UNITED STATES PATENT AND TRADEMARK OFFICE

APPLICATION NO.	FILING DATE	FIRST NAMED INVENTOR	ATTORNEY DOCKET NO.	CONFIRMATION NO.
10/622,346	07/19/2003	Saravuth Sirinorakul	NSE006 US	4811

Office Action Summary

DETAILED ACTION

Yamazaki et al. teach a semiconductor die package (Figs. 3 and 4), comprising:

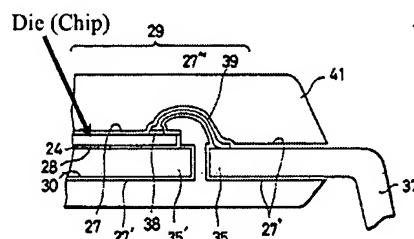
5. Claims 1, and 3 are rejected under 35 U.S.C. 102(b) as being anticipated by US Patent No. 5,013,688 to Yamazaki et al.

a semiconductor die (Fig. at right);

a leadframe (29; Figs. 3(B) & 4);

a capsule (shown as (41) at right)

enclosing the die and a portion of the leadframe.

Yamazaki et al. further teach that the surface of the leadframe is roughened (Col. 2, lines 31 – 41), which would have resulted

in enhanced adhesion. Yamazaki et al. do not teach that the roughened surface is achieved by chemical etching. However, this is considered a product-by-process limitation. "Even though product-by-process claims are limited by and defined by the process, determination of patentability is based on the product itself. The patentability of a product does not depend on its method of production. If the product in the product-by-process claim is the same as or obvious from a product of the prior art, the claim is unpatentable even though the prior product was made by a different process." In re Thorpe, 777 F.2d 695, 698, 227 USPQ 964, 966 (Fed. Cir. 1985).
